Re: St. Lucie Plant Unit 1
Docket No. 50-335
Renewed Facility Operating License No. DPR-67

Response to Nuclear Performance and Code Review Branch Request for Additional Information Identified During an Audit of Analyses Supporting the Extended Power Uprate License Amendment Request

**Response to NRC Nuclear Performance and Code Review Branch
Request for Additional Information**

Figure 1

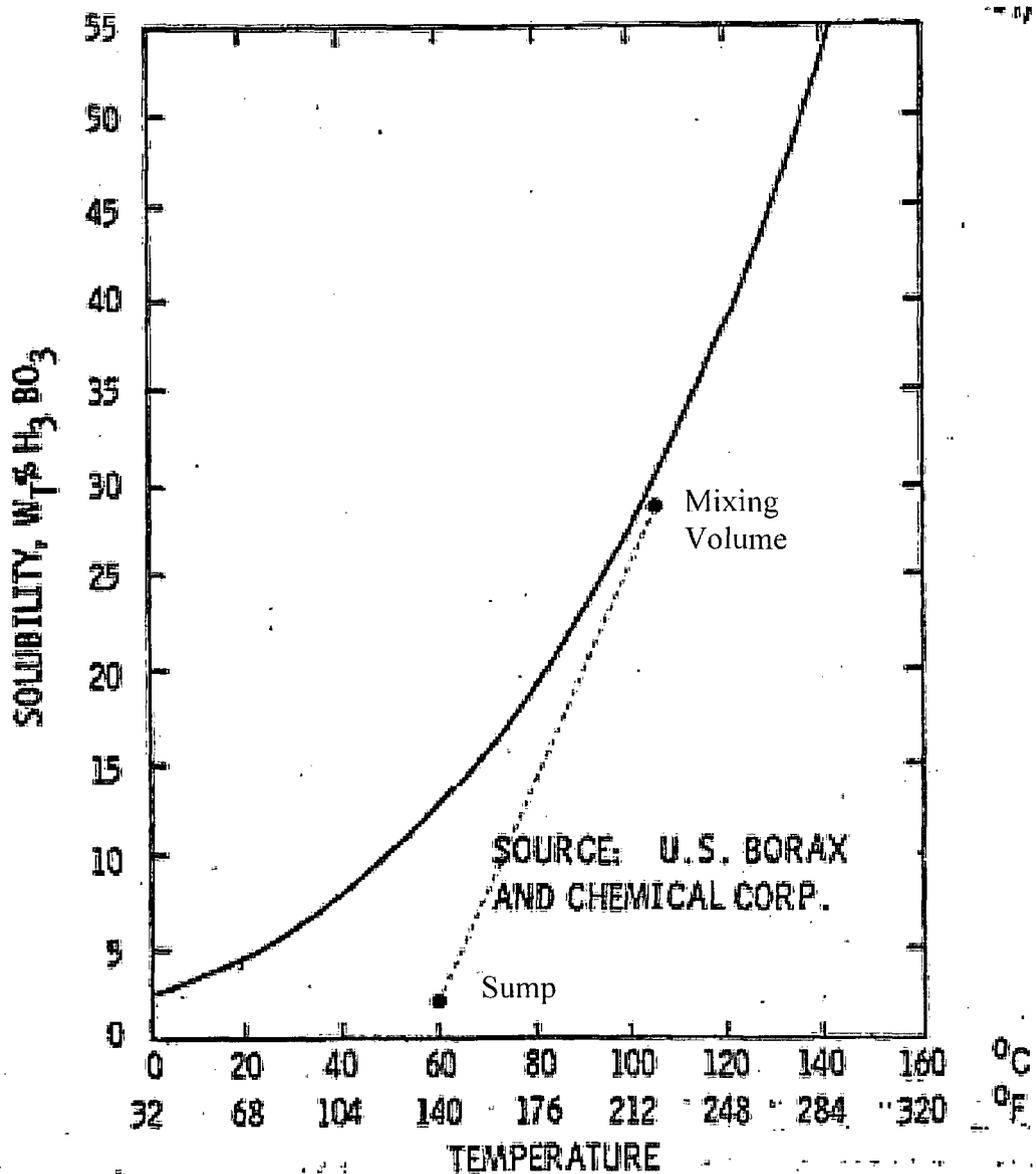
Provide additional justification for reactor vessel bottom head temperature vs. time following initiation of simultaneous hot and cold leg injection, and explain how this could impact precipitation.

From 6-9 hours post-LOCA, sump water temperature, based on a double-ended break in the discharge leg with a failure of an emergency diesel generator, is on average 185 °F. When sent through the SDCHX, this liquid temperature will drop to on average 140 °F. For this evaluation, it is then assumed that the liquid remains at 140 °F when injected into the cold leg (only CLI is looked at here, as any HLI that eventually ends up in the lower plenum will have passed through the core, where it will heat up significantly due to decay heat). This is conservative, as it ignores any increase in temperature due to pump heat or heat transfer from the walls of the injection piping.

Figure 1 documents the effect that this colder injection liquid can have on the boric acid concentration and the potential for precipitation. As seen in Figure 1, the injection flow is at a cold temperature, but it is also at the boric acid concentration of the sump (maximum of 1.2 wt% from 6-9 hours post-LOCA). The mixing volume is assumed to be at saturation conditions for a boric acid solution (i.e., saturation temperature of 218 °F). Once the liquid from the sump enters the lower plenum, mixing will begin to occur. As the sump liquid mixes with the mixing volume liquid, both the temperature and boric acid concentration of that liquid will increase. At 6-9 hours post-LOCA, the mixing volume maximum boric acid concentration is 28.4 wt%. Figure 1 illustrates these values for the injected flow (sump) and the mixing volume, and as shown, both remain under the solubility limit. The dotted line seen in Figure 1 illustrates how the boric acid concentration of the liquid will change as mixing occurs, until the liquid is fully mixed into the mixing volume. Again, looking at this line shows that the maximum concentration will never cross the solubility limit, and therefore, boric acid precipitation is precluded.
